TOWN OF NEWBURGH PLANNING BOARD TECHNICAL REVIEW COMMENTS

PROJECT:THE POLO CLUB SENIOR HOUSING-FSEISPROJECT NO.:18-12PROJECT LOCATION:SECTION 39, BLOCK 1, LOT 1 & 2.12REVIEW DATE:11 DECEMBER 2020MEETING DATE:17 DECEMBER 2020PROJECT REPRESENTATIVE:ENGINEERING & SURVEYING PROPERTIES

RE: POLO CLUB – RESIDENTIAL DEVELOPMENT TOWN OF NEWBURGH RESPONSES TO FSEIS COMMENTS

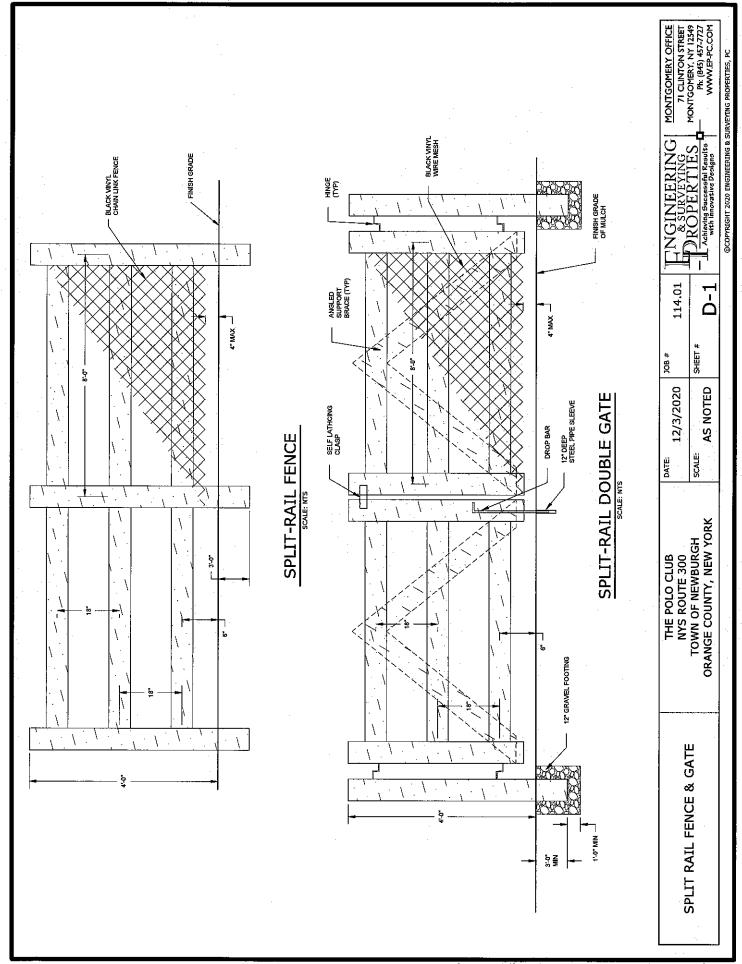
8. Please adjust plant label size as it is difficult to read. The size of the plant is not necessary on plant labels, just the plant list.

<u>Response</u>: Making this change is not easily accomplished as increasing the label size would eliminate the space for labeling and the labeling would likely become more confusing.
